**REQUEST FOR TENDER
ORANGUTAN OUTDOOR EXHIBIT CONSTRUCTION
RFT#: TZC T 10-2020-02
ADDENDUM # 2**

Date Issued: 2020 March 13
Project Name: **Toronto Zoo Orangutan Outdoor Exhibits**
To: Ben Knoop
Toronto Zoo
361A Old Finch Avenue
Toronto, ON M1B 5K7
Project Number: 18-1-086
RFT Reference No.: TZC-T-10-2020-02 (issued 2020-02-18)

ADD #A002

3 CONSTRUCTION PLAN - UPPER LEVEL
AR-140 SCALE - 1:50

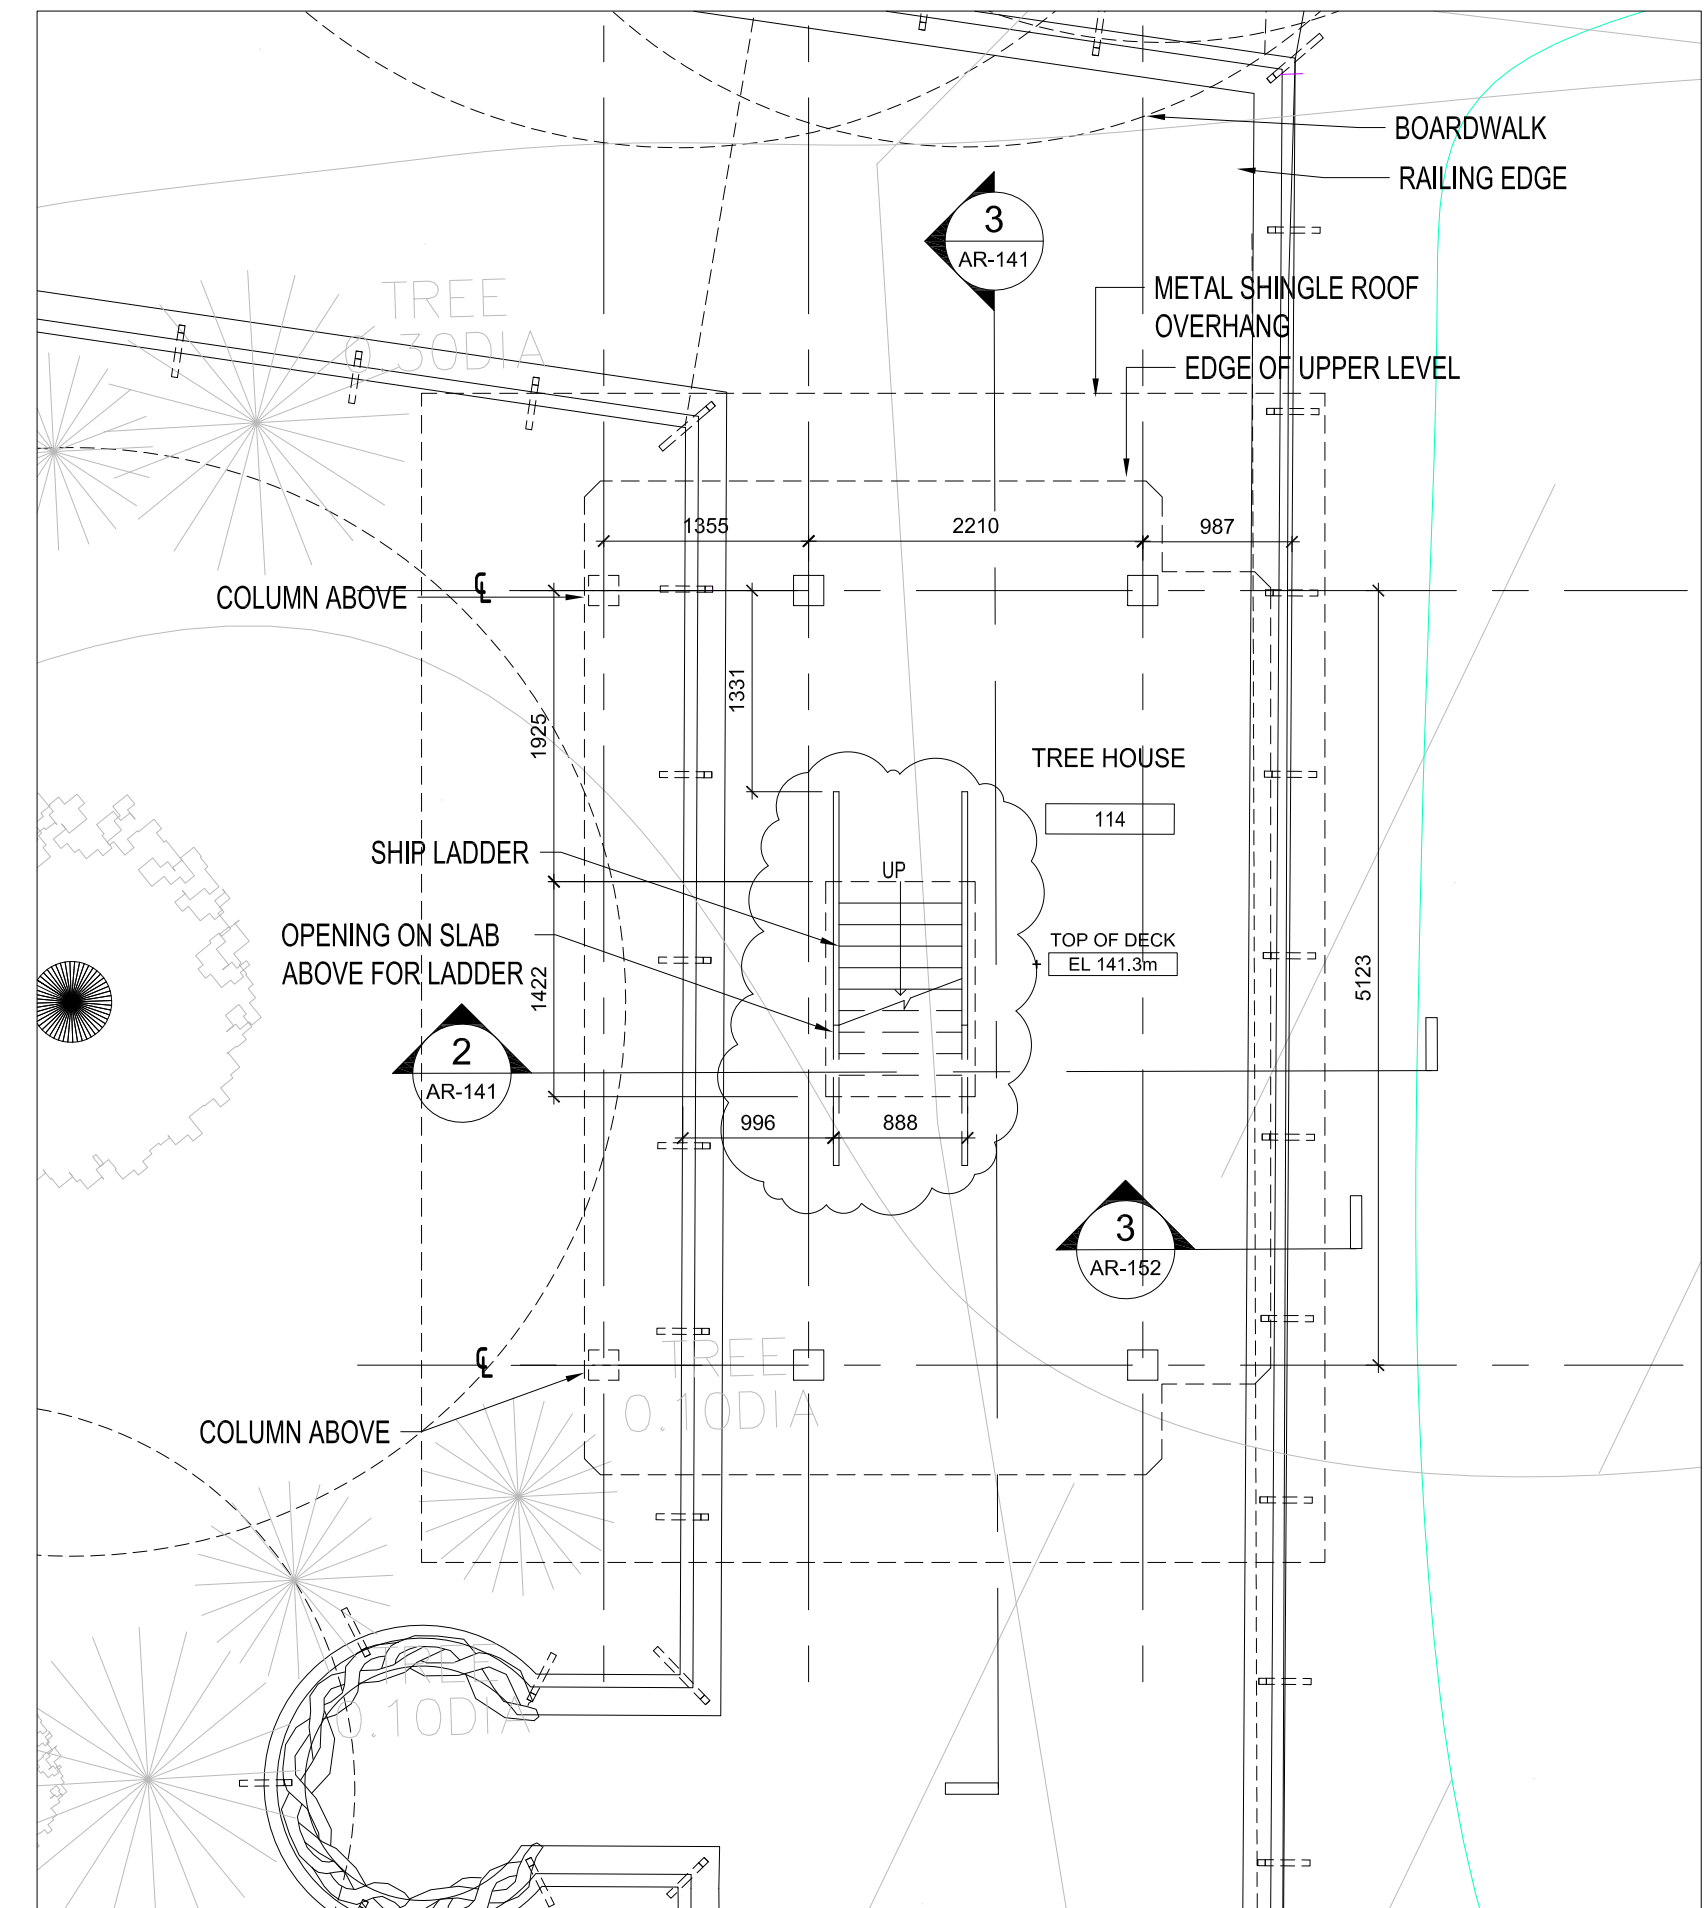
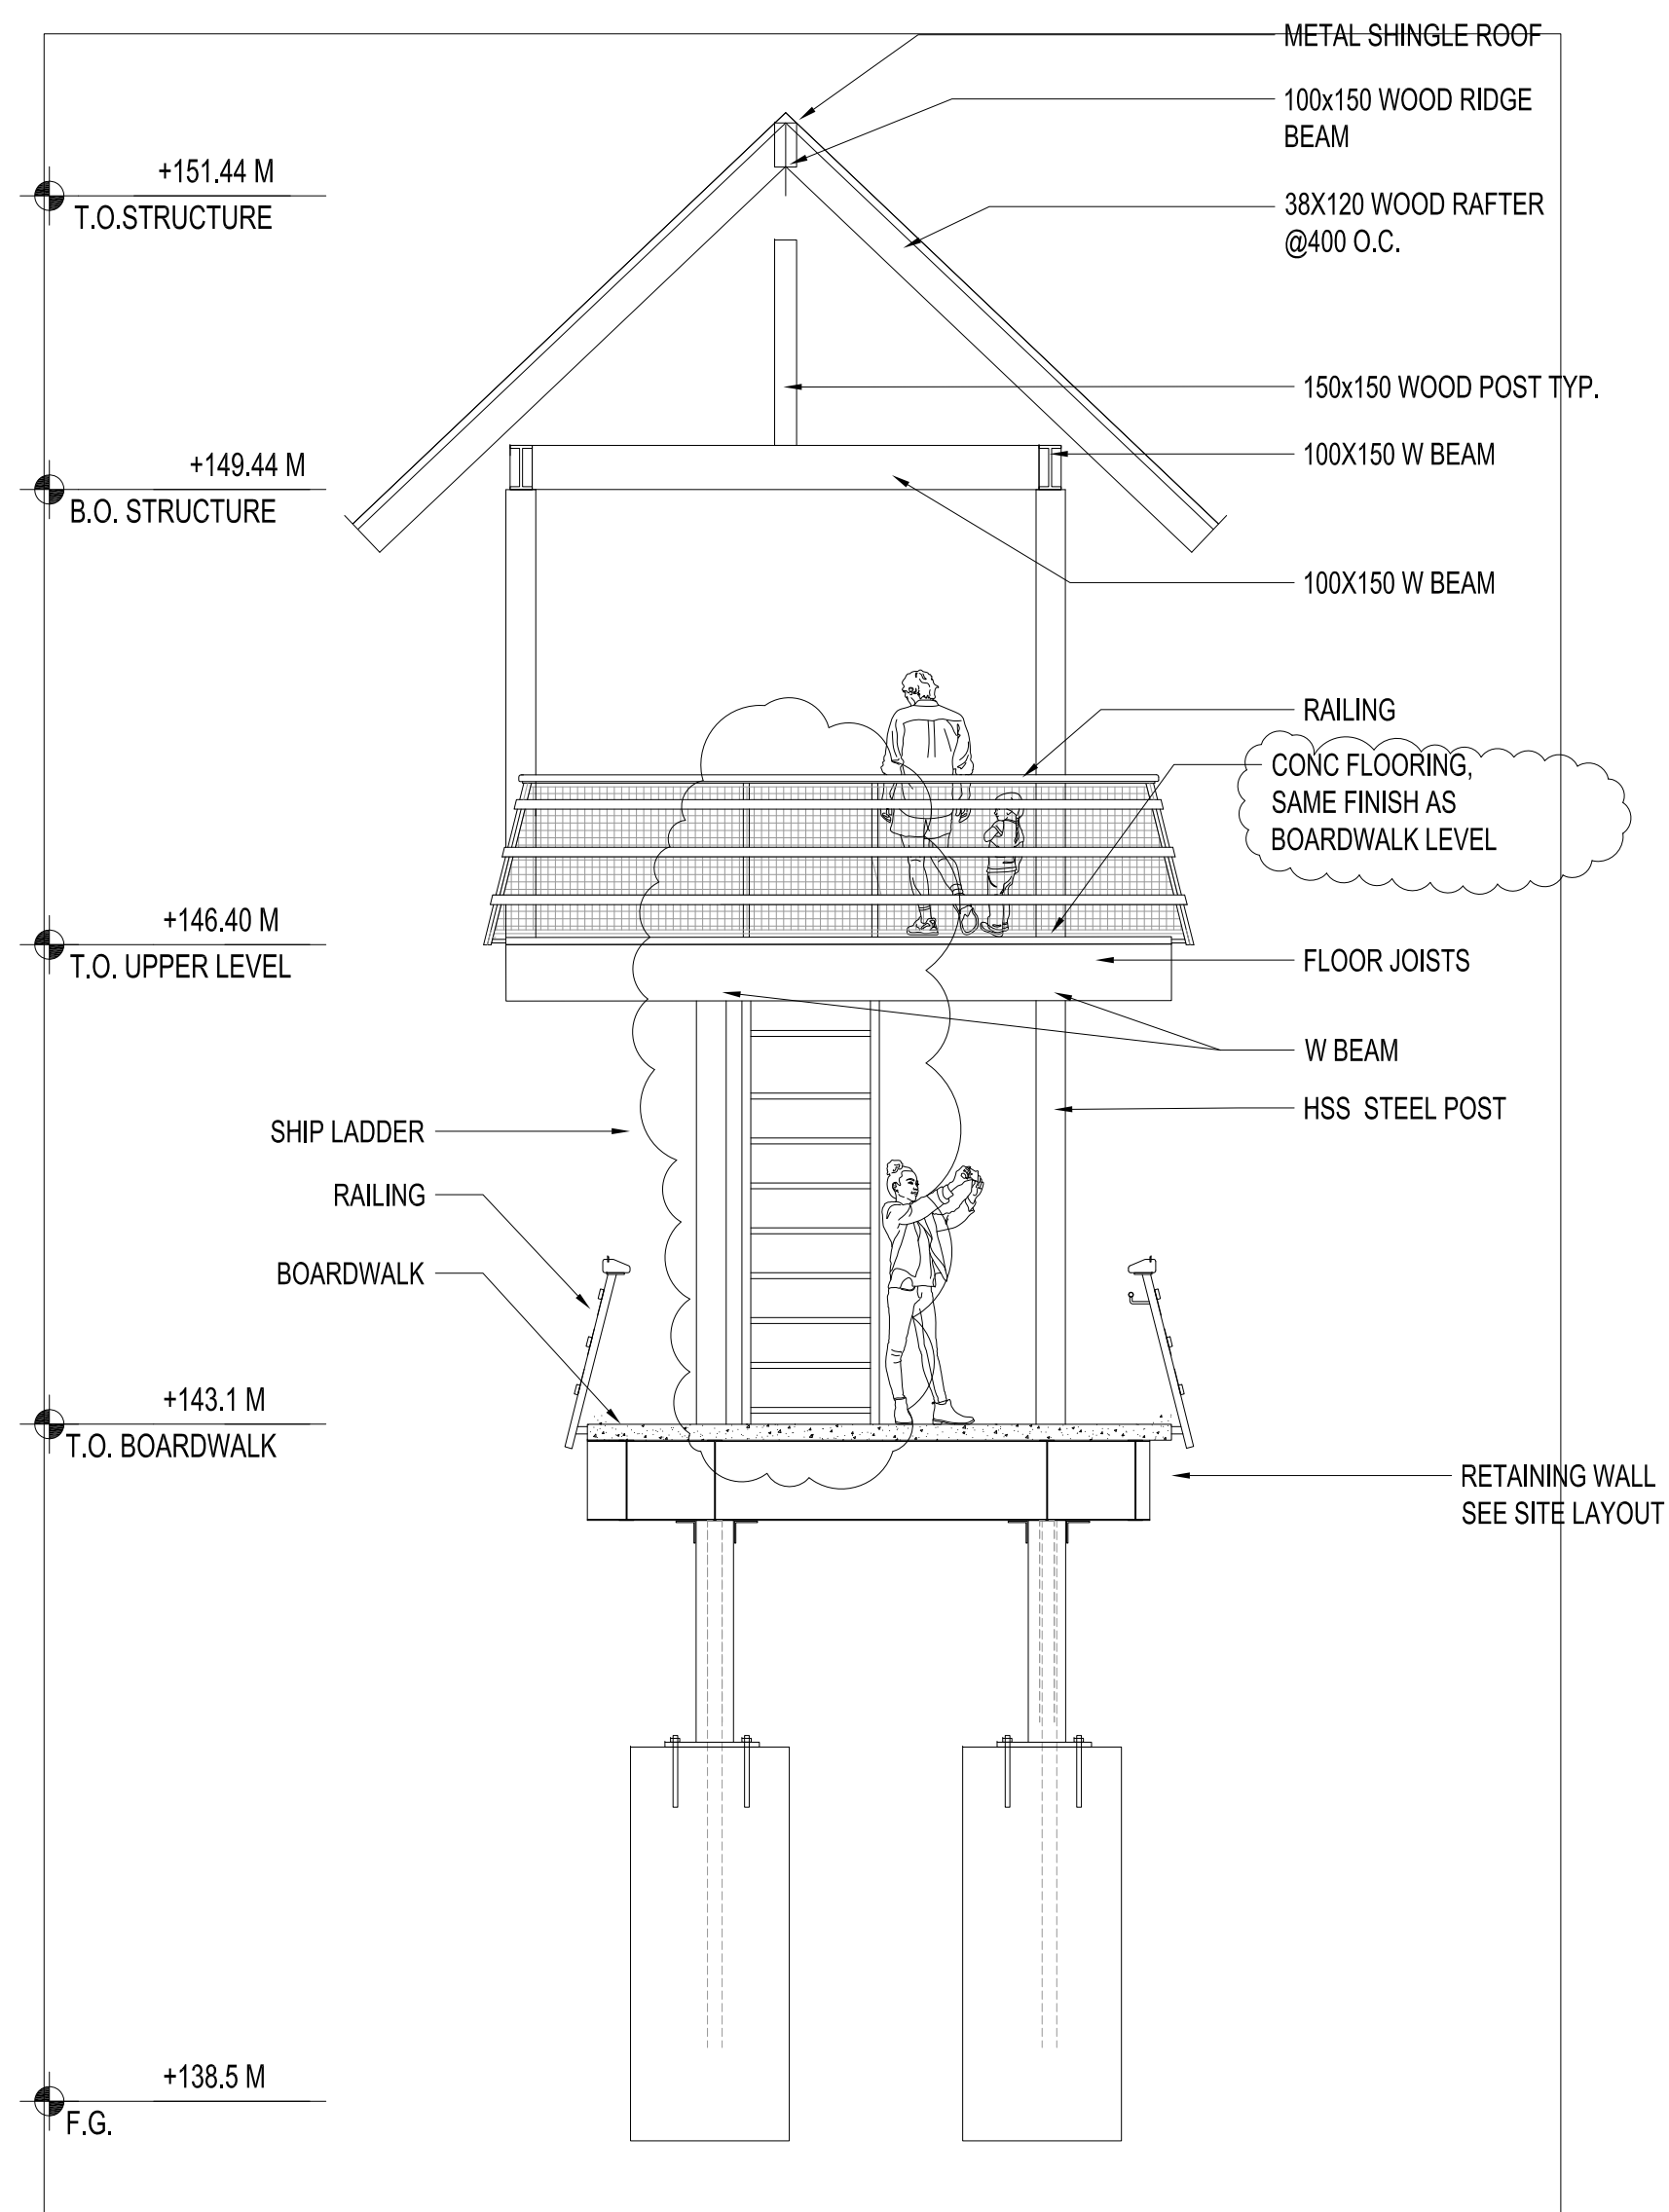
(A)		7 Drawing 3/AR-140 & 2, 3, 4/AR-141 – The upper floor deck is concrete on metal deck as per structural plan 3/S-210 & section 2, 3/S-810. Not cedar floor. Please clarify.	Zediler/RJC	Arch details to be revised to match structural's dwg (conc on metal deck).
